DAVIS
PARTNERSHIP
ARCHITECTS

ADDENDUM NO: 03

Date Issued: December 9, 2015

**Re: Red Rocks Community College
Student Recreation Center**
Construction Documents, Dated November 9, 2015
Architect's Project No. 15803.00

S-104

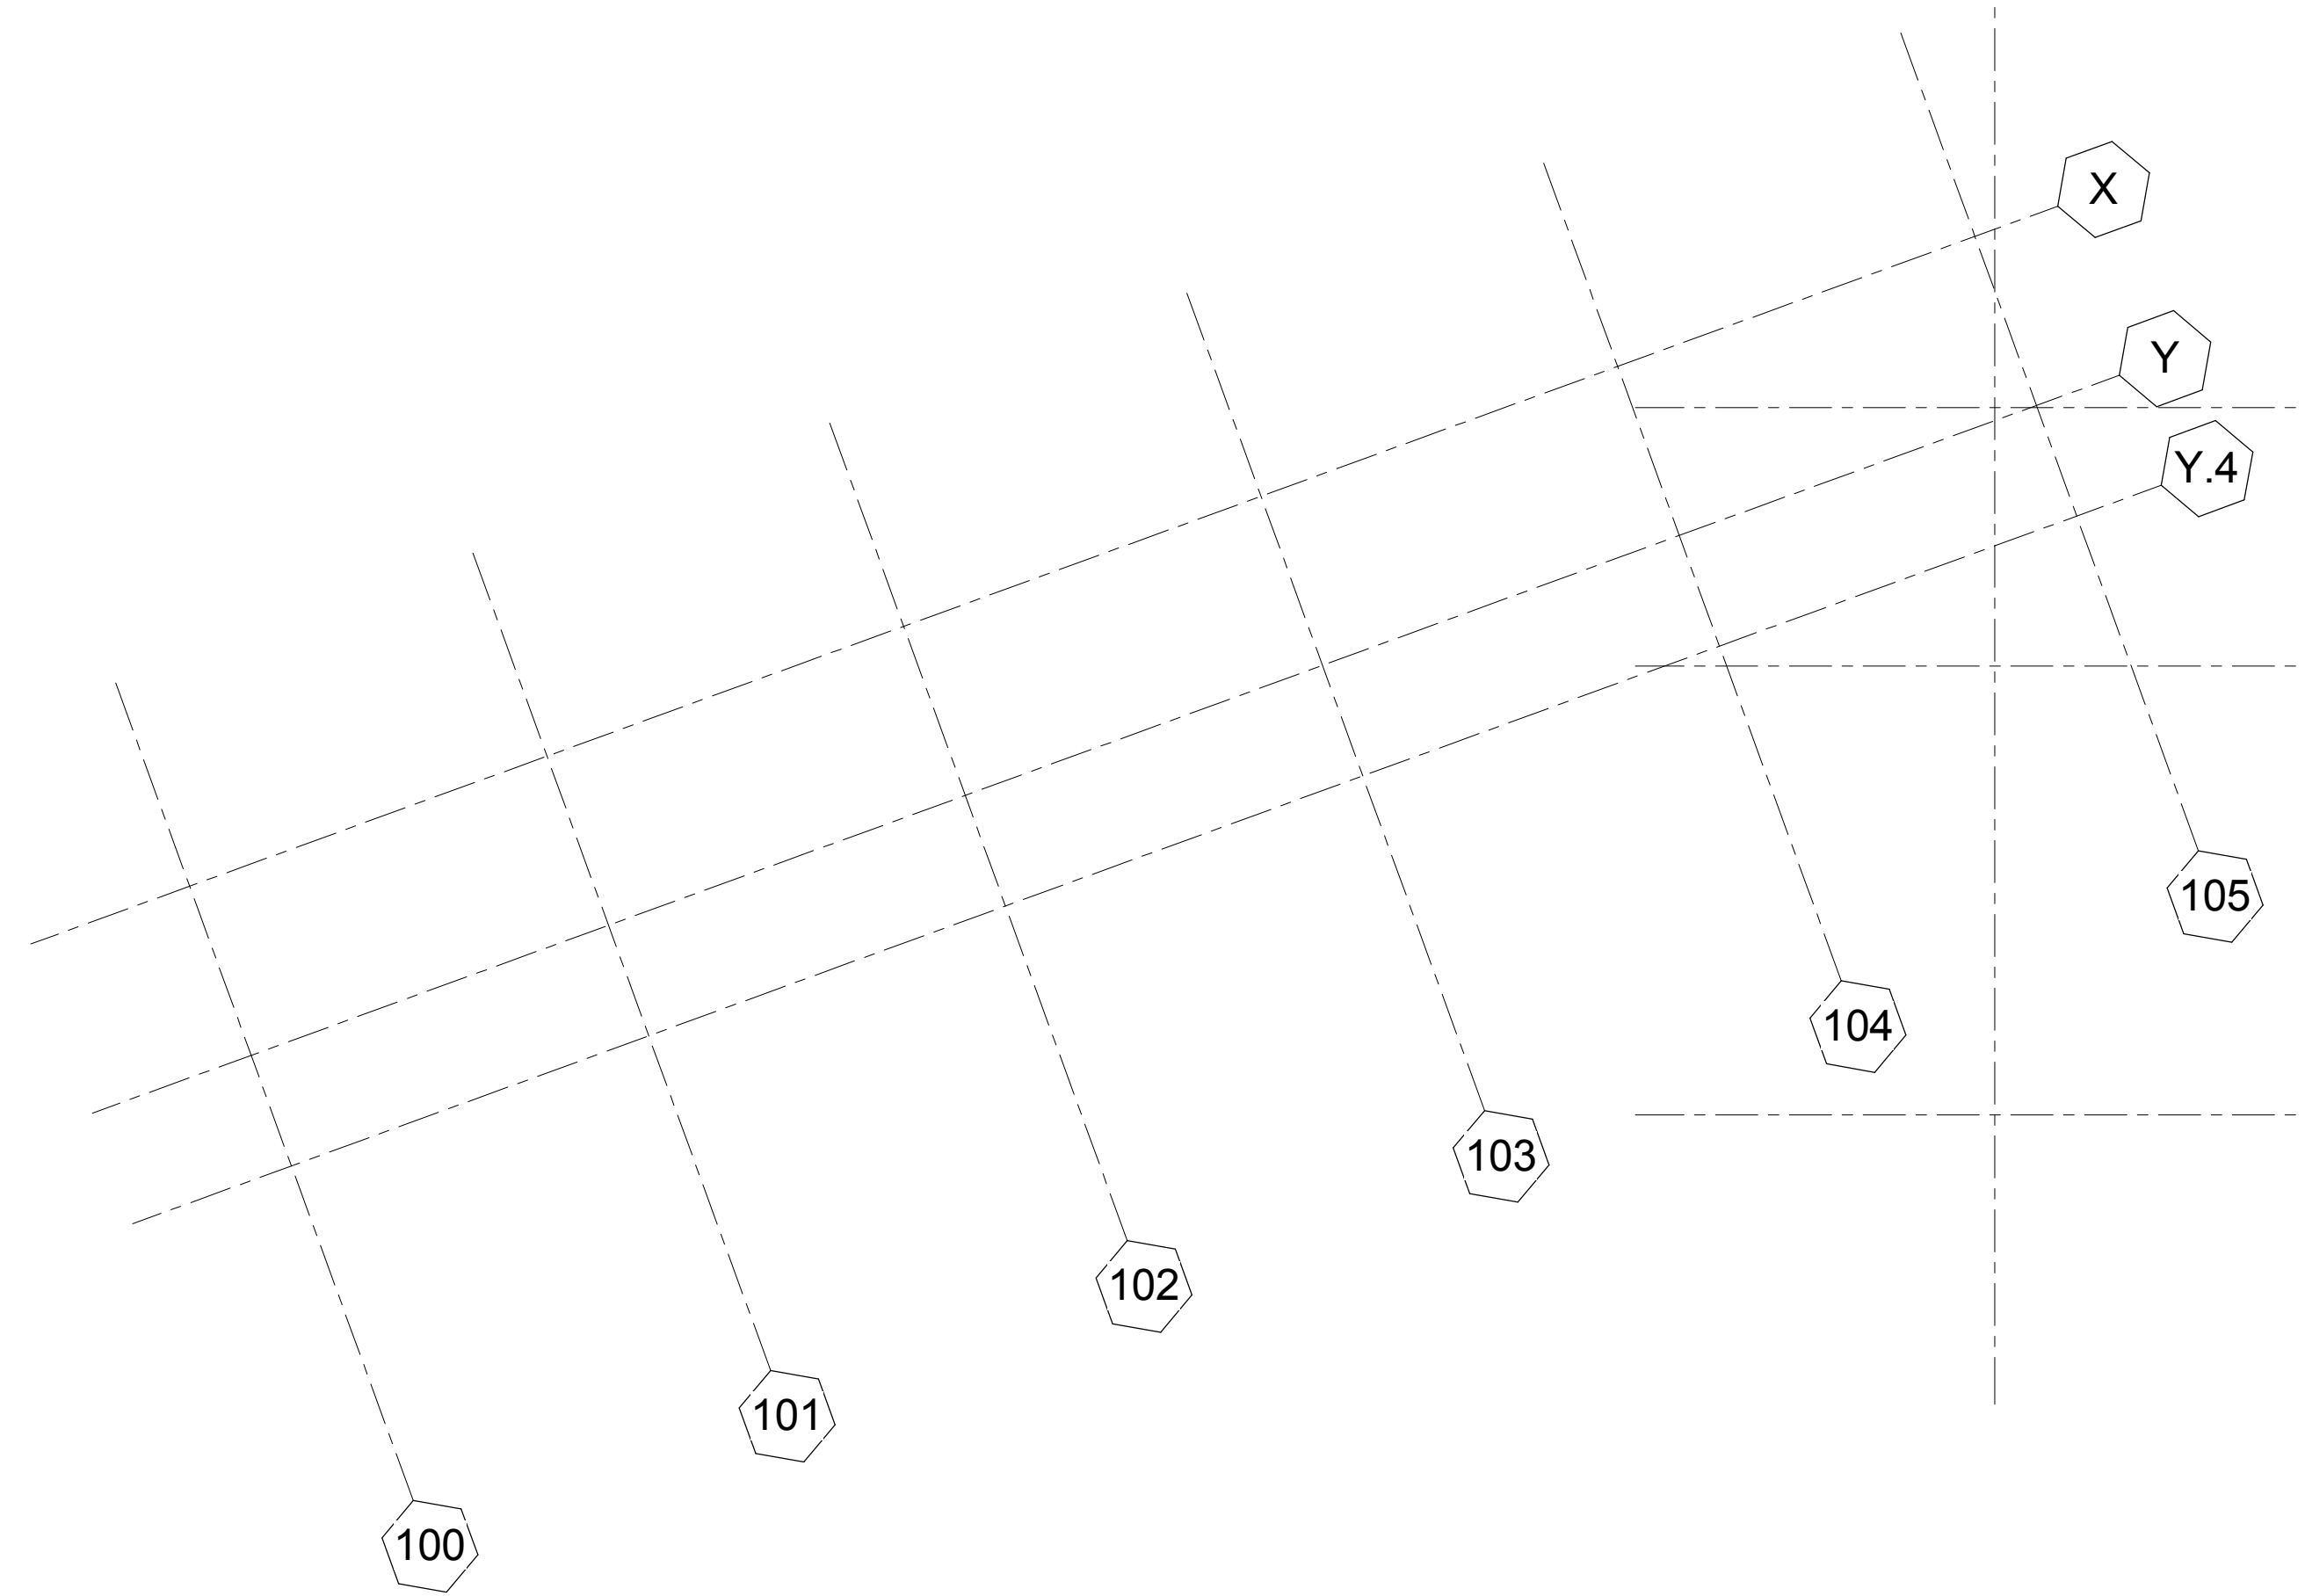
ADD. #3-63. Revised high roof framing plan:

1. S-104: Moved detail 16/S-506.
2. S-104: Added diagonal braces west end of grid 4.
3. S-104: Updated extend of roof overhang.

5 3/16" = 1'-0" LEVEL 2 SOUTH ENTRY

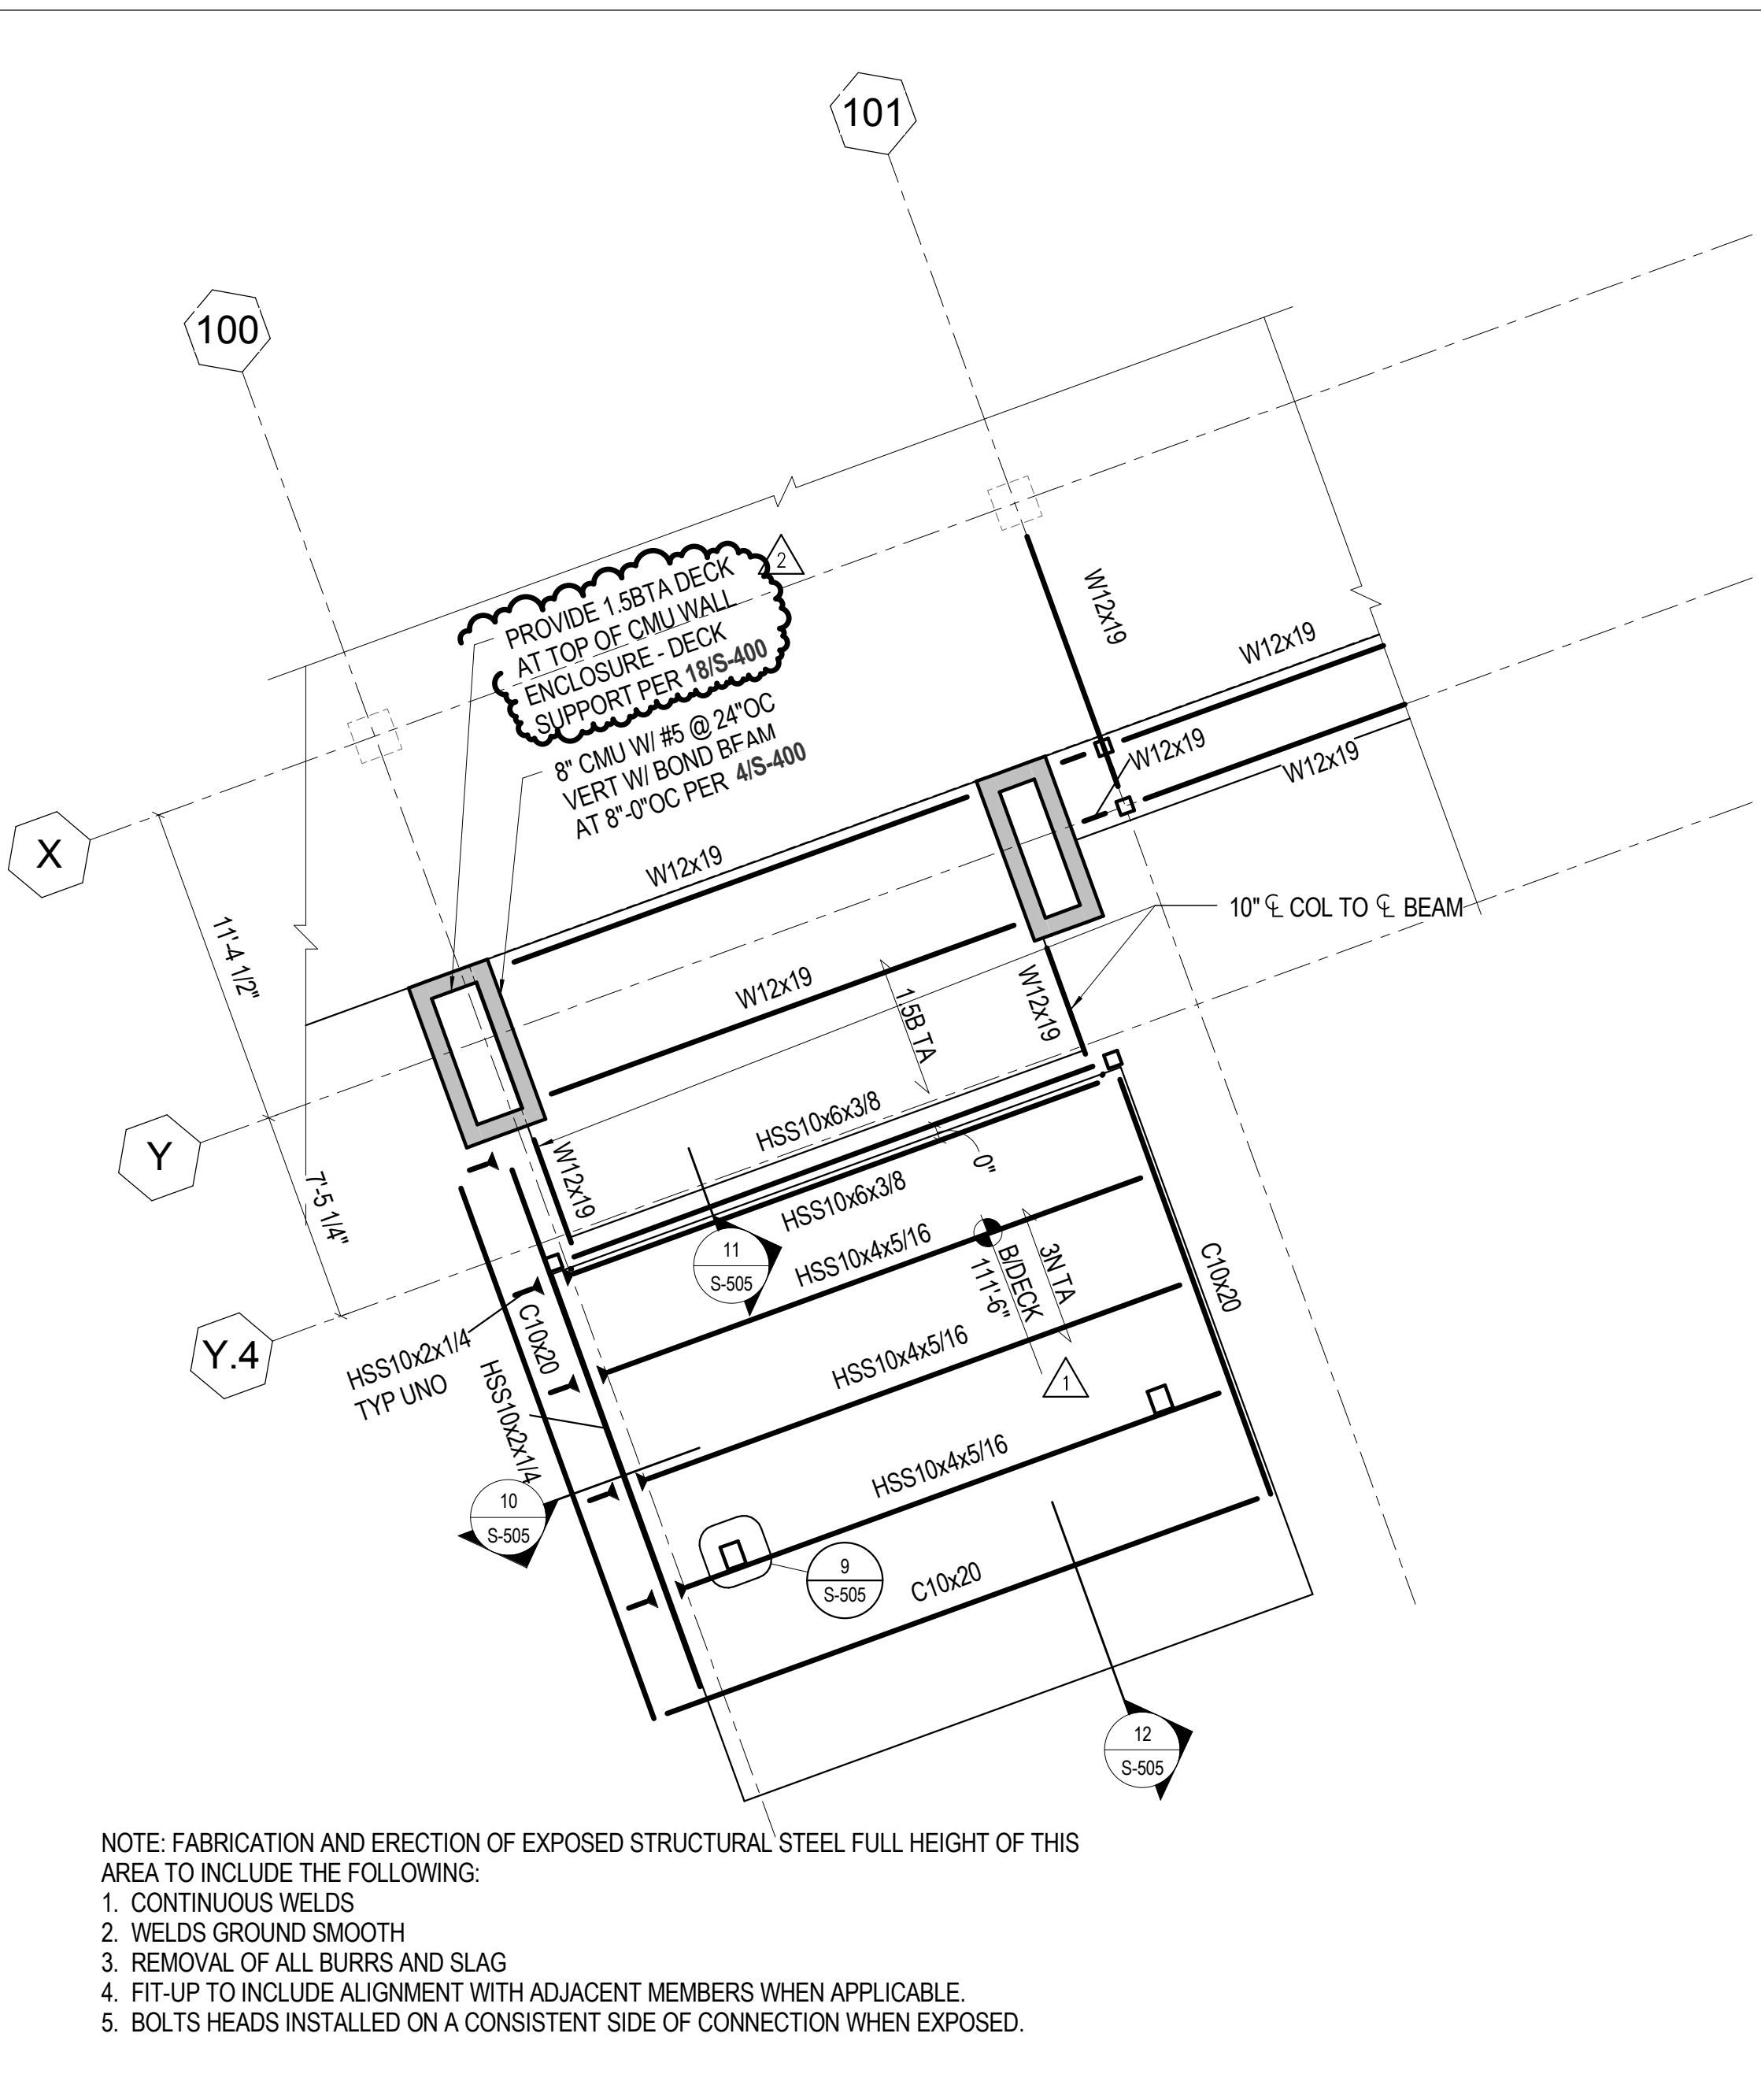
ADD. #3-64. Clarified entry framing:

1. 5/S-105: Added note for deck at top of CMU wall enclosure.
